**MEETING OF THE
PLANNING AND ZONING BOARD
QUASI-JUDICIAL PUBLIC HEARING**

November 3, 2015

1145 1167 100 STREET - CONDOMINIUM

Subject: Site Development Plan Application
1145 100th Street – 45 DU Multi-family Residential Complex
1145 100th Street
Bay Harbor Islands Acct. No. MB2015-161
MMPA Acct. No. 01-0702-1024

DRAWING TITLE	
LEVEL 1 FLOOR PLAN	
SCALE: 3/32" = 1'-0"	DATE: OCTOBER 14, 2015
SHEET NUMBER A-1.01

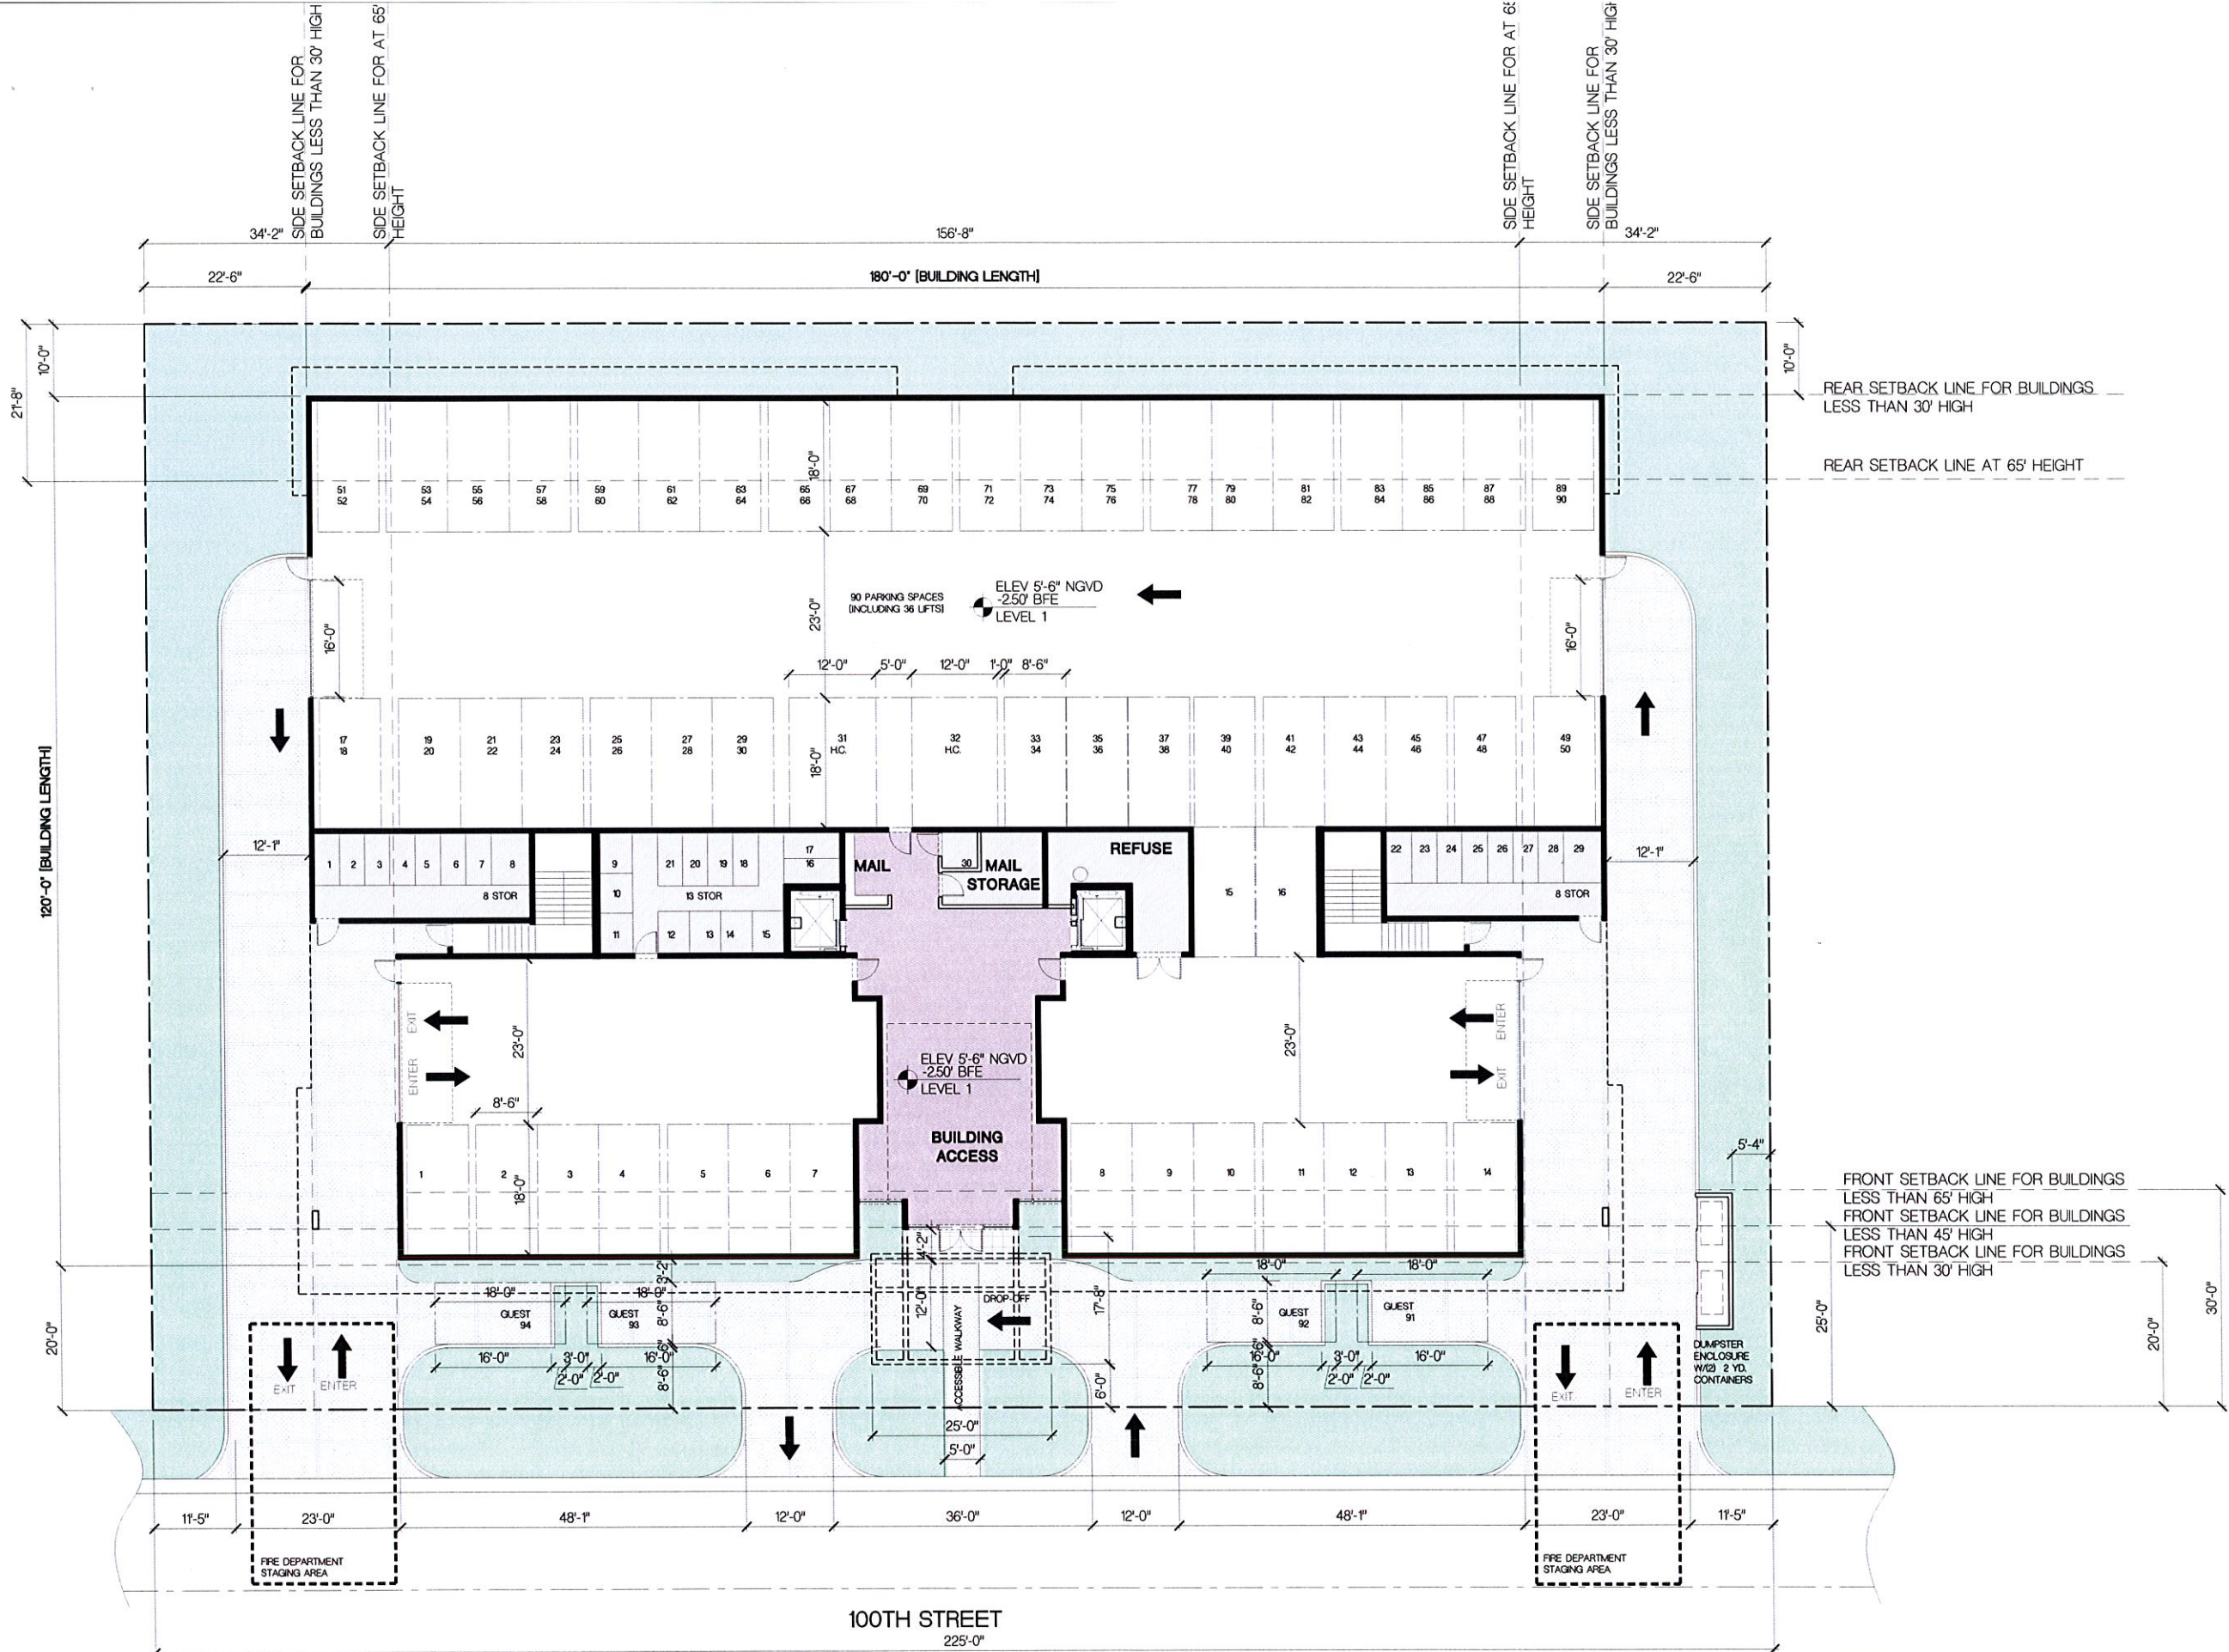
- 3) Some of the balconies are deeper than the Code allows. Per Section 23-12(15)(a)(vi), balconies in the front (street) yard may encroach up to 4' into the setback with a maximum depth of 6' unless the Town approves otherwise (depth only) during site plan review. The applicant meets the setback requirement but seeks balcony depths of up to 7'-0" in the front yard on Level 2. Specific Planning and Zoning Board approval is required for the increased depth of the balcony on Level 2.

- 4) The applicant is requesting permission to reduce the normal 10-foot wide front yard landscape strip to 8' for the drop-off area and 8'-6" for the guest parking spaces. The Town Code allows a dimensional reduction as low as 7' if the Town approves the site design. Planning and Zoning Board approval is required.

DRAWING TITLE
SIDE ELEVATION
SCALE: 1/8" = 1'-0" DATE: OCTOBER 14, 2015
SHEET NUMBER
A-2.02A

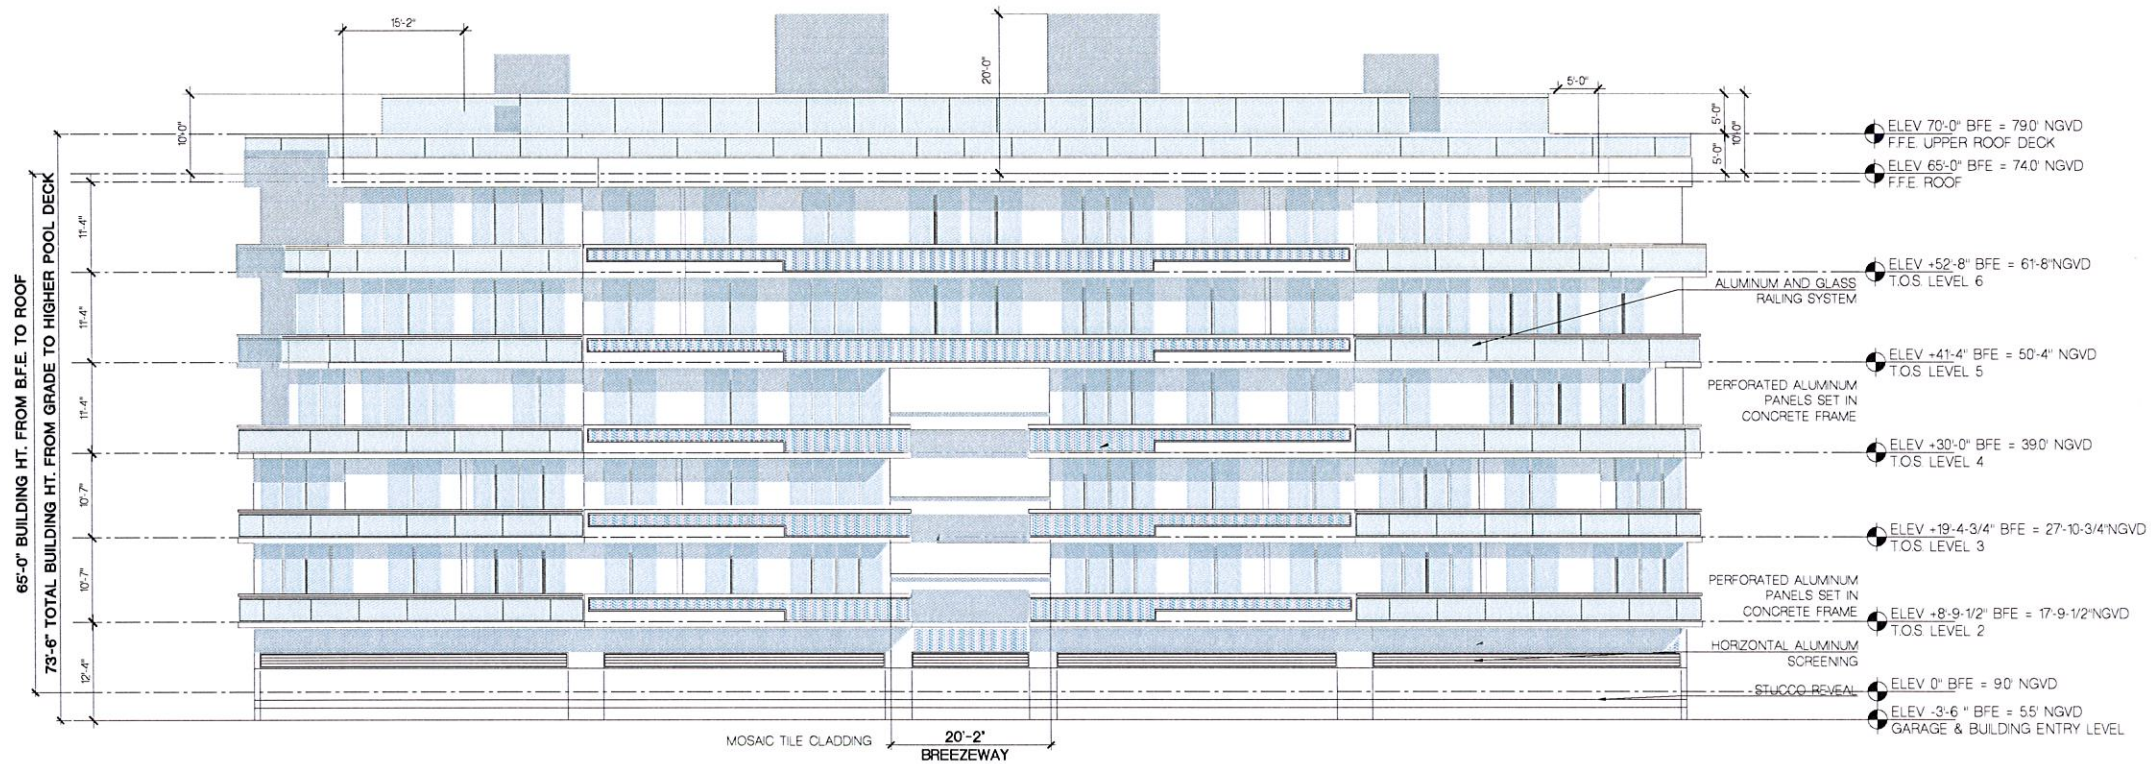
- 5) The building exceeds one hundred twenty (120) feet in length (shown at 180'-0"); therefore, a "breezeway" is required. The applicant is proposing a 20'-2" breezeway completely through the building, except for the top two floors, which only have a breezeway in the front of the building (not completely through in the rear). Section 23-11(B2)(6) states that breezeways shall have a minimum unobstructed width, completely through the building, of at least 20 feet, unless the Planning and Zoning Board finds that enhanced architectural articulation and detailing is provided on the building facade to break the massing of the building. As the applicant's breezeway design is limited to the first 4 Levels the Planning and Zoning Board must find that the architecture is enhanced enough to waive the breezeway requirement for the top two floors.
